Request for an Evidentiary Hearing and Waiver of Right to a Decision within 120 Days

Date Land Use Application received by BDS 1-31-22 Case File No. 22-107111 DZM

REGARDING: Type of Land Use Review Design Review

Site Address/Street 1122 SE Ankeny St

VIEW ALONG 12TH

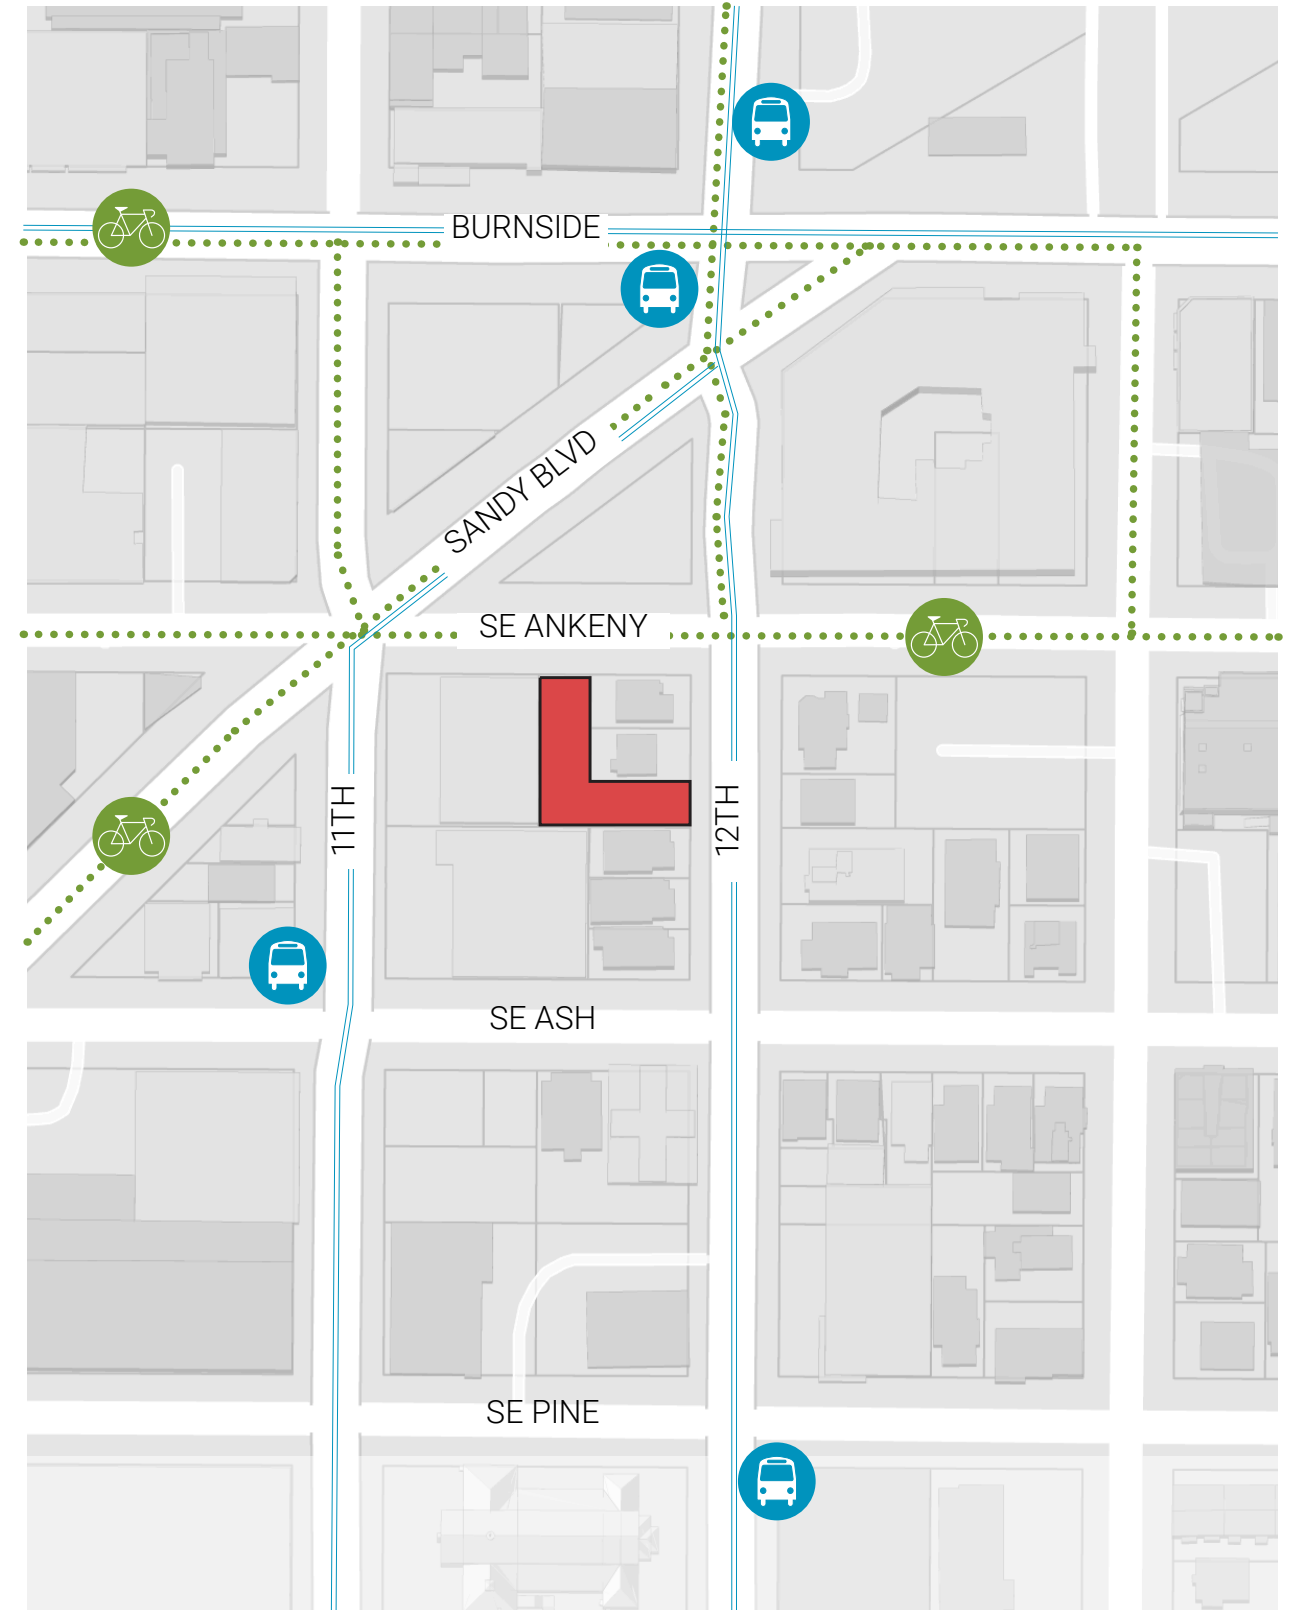
Building scale, height change and set back on 12th providing more solar access and buffering to neighboring homes appreciated.

PUBLIC REALM

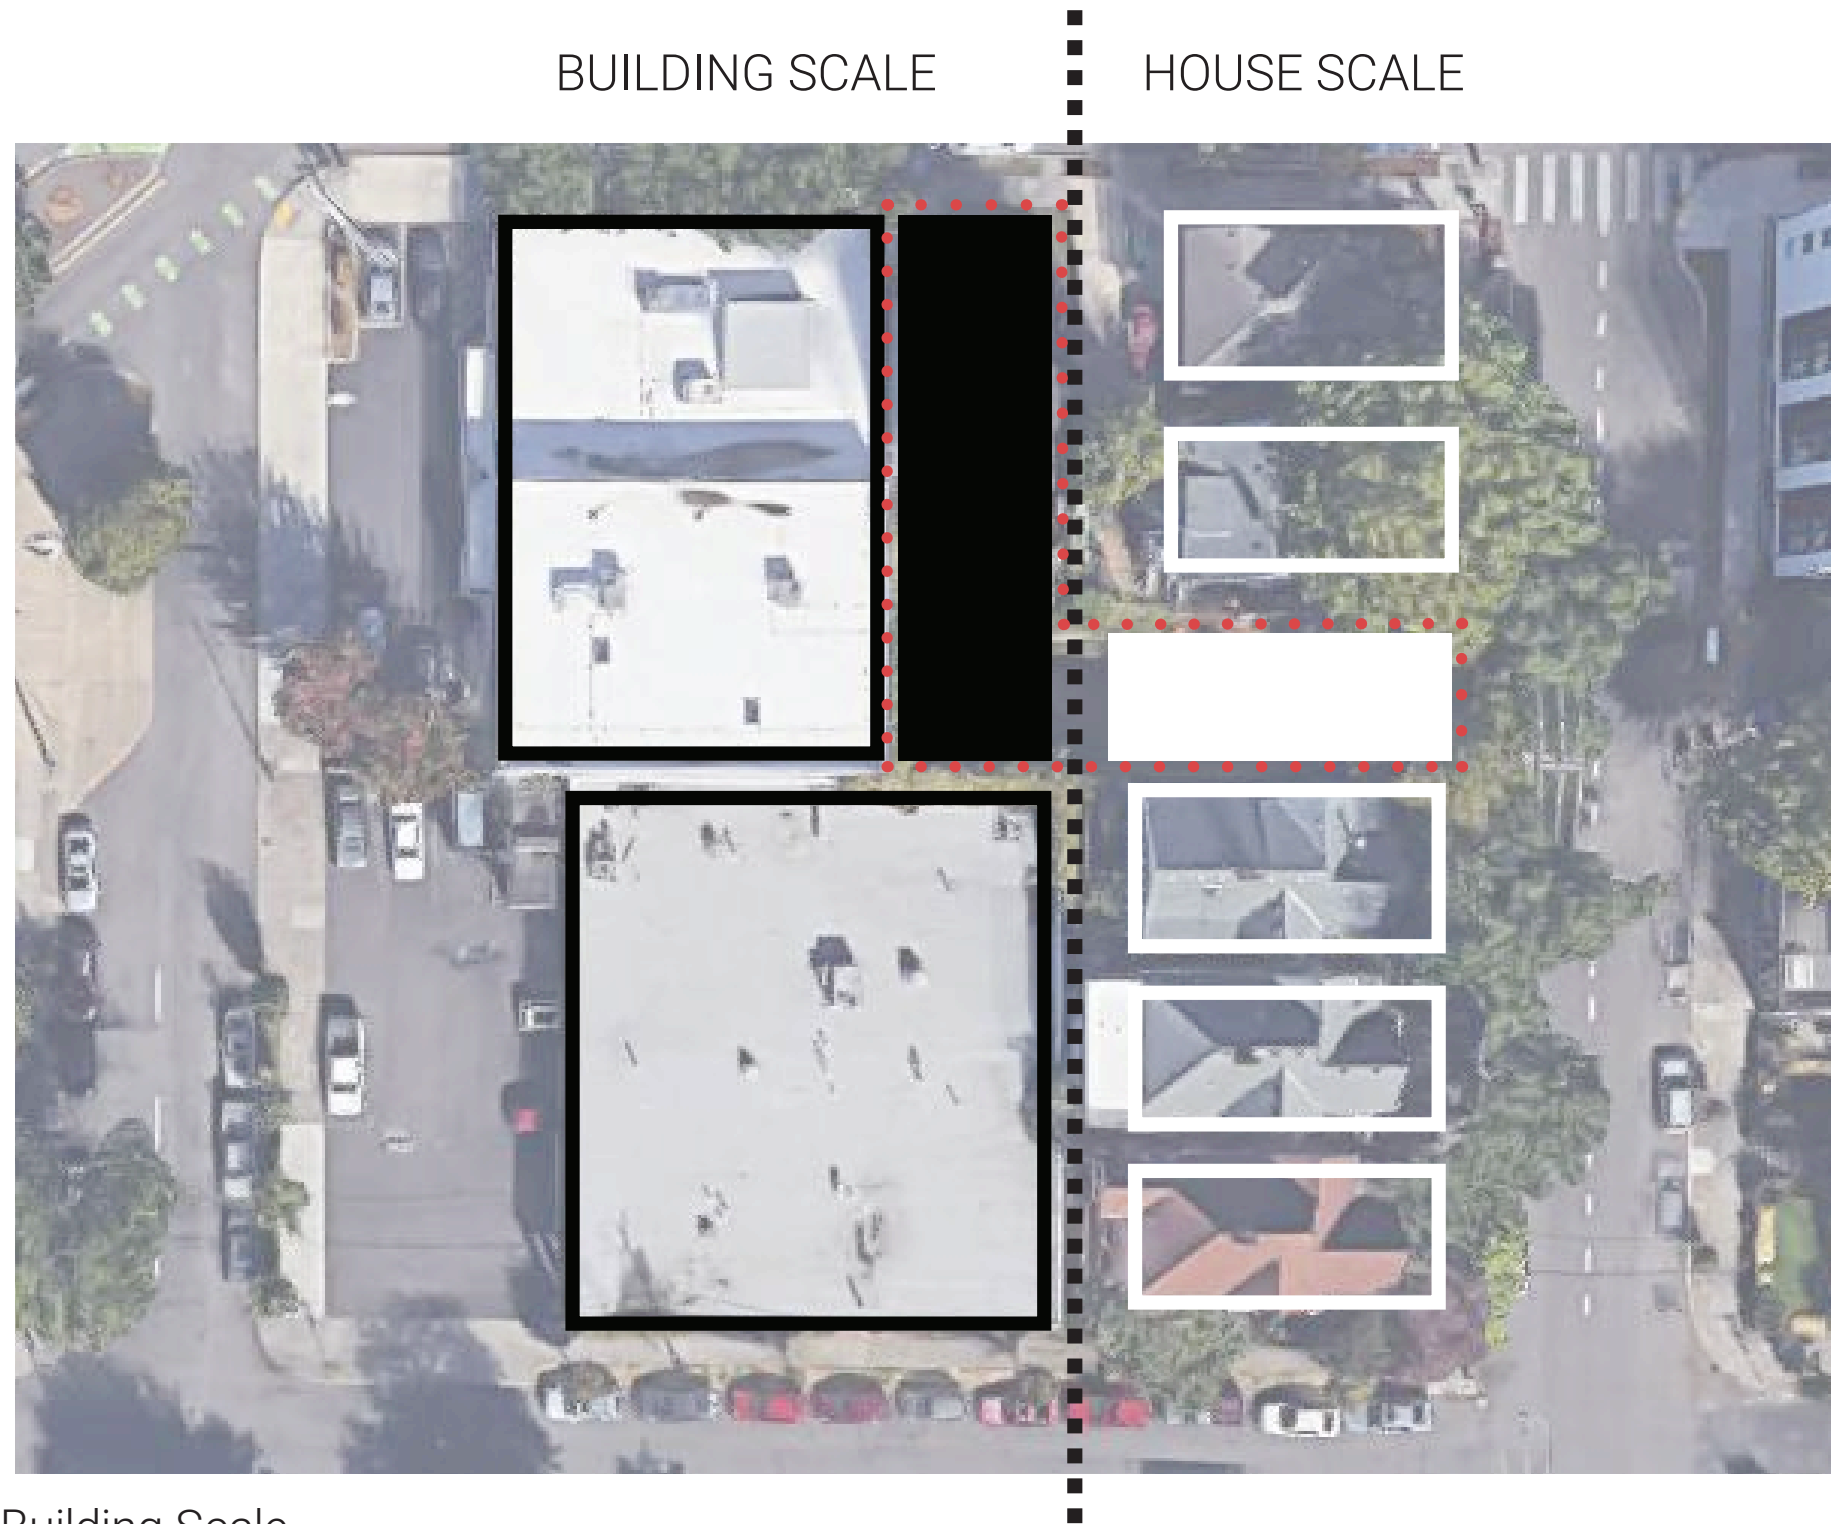
Entry facade on 12th needs to more intentionally respond to it's context with materiality, landscaping and detailing. Larger portion of building should limit it's impact on the solar access to adjacent properties and use landscaping to increase privacy and bring down scale.

Ground floor with glazing, art and active spaces and direct access to bike room from street well received.

Canopies and a more inviting entry on 12th desired. Reduction in landscaping opposed given the existing context on the street.

More information needed about the quality of materials as well as the detailing of the facade.

QUALITY & PERMANENCE

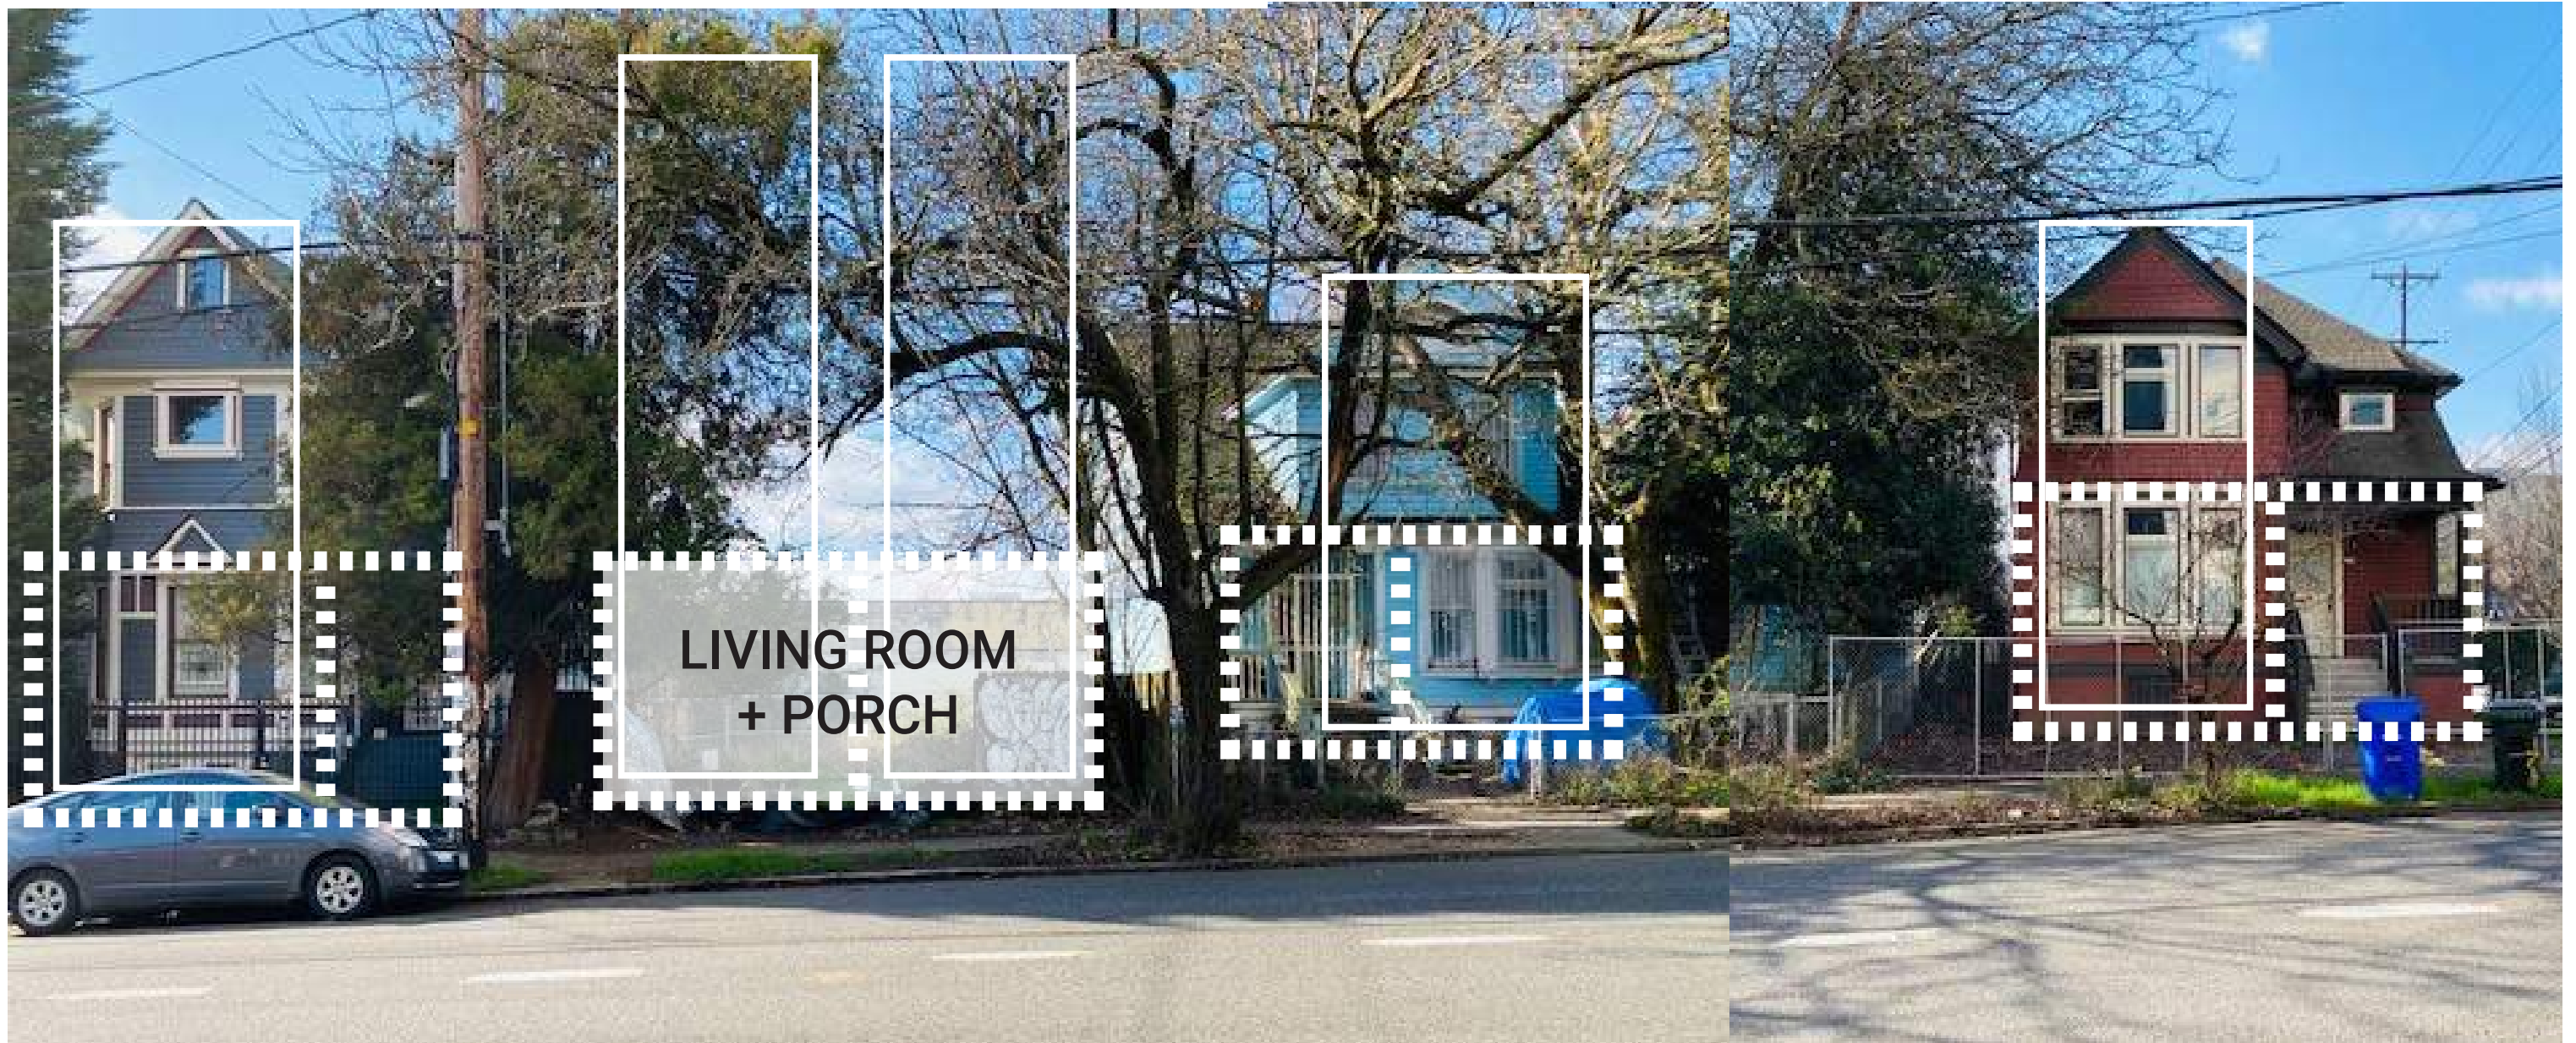
Composition and application of materials well received.

More information needed about the quality of materials as well as the detailing of the facade.

PUBLIC REALM

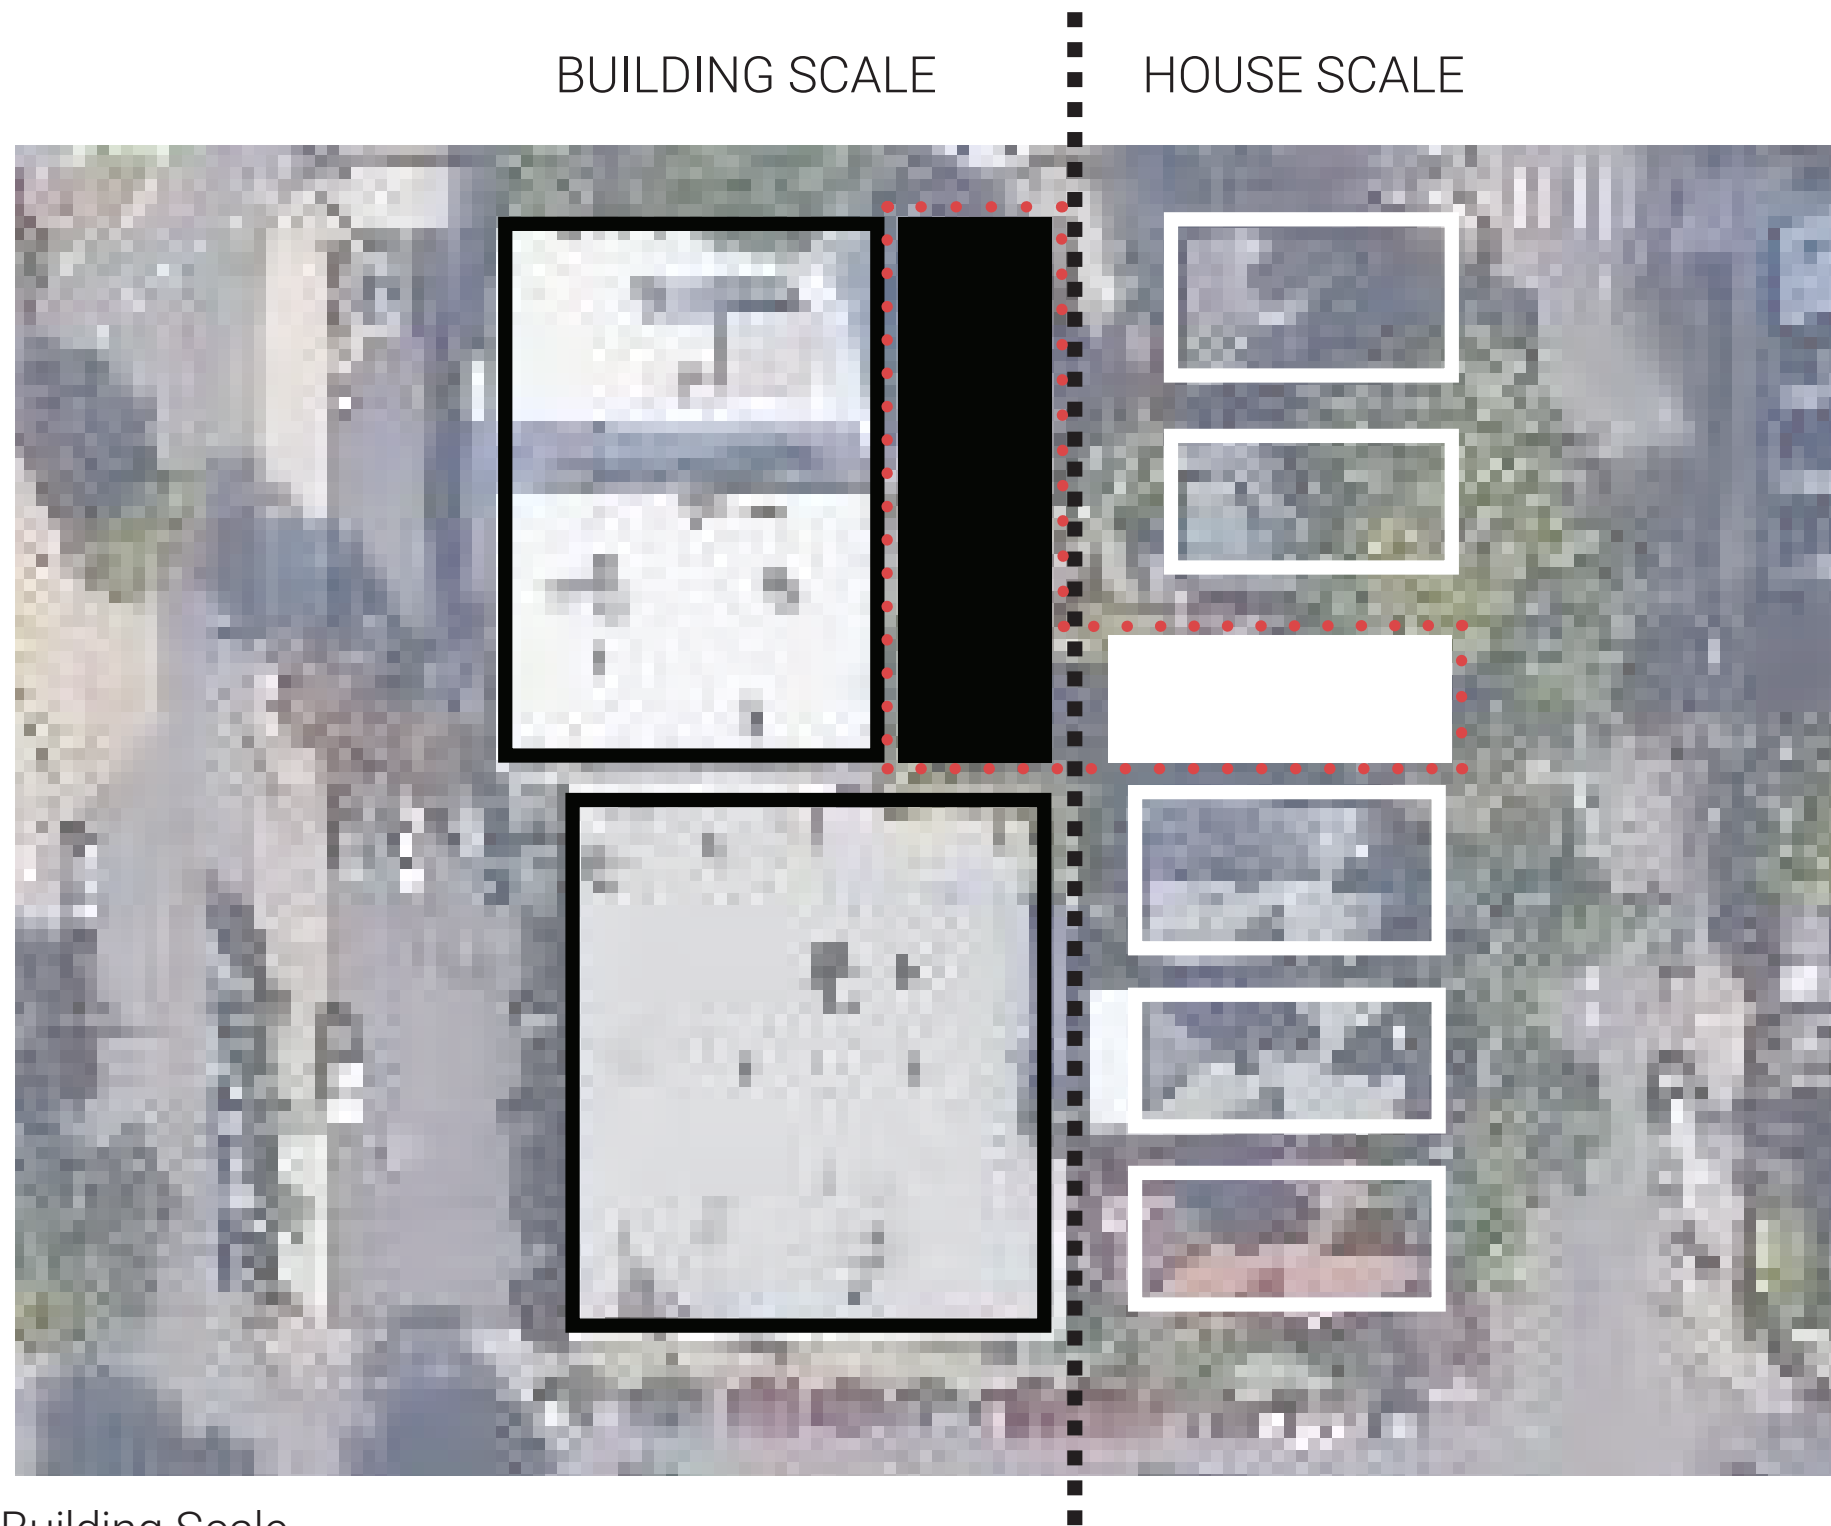
Ground floor with glazing, art and active spaces and direct access to bike room from street well received.

Canopies and a more inviting entry on 12th desired. Reduction in landscaping opposed given the existing context on the street.
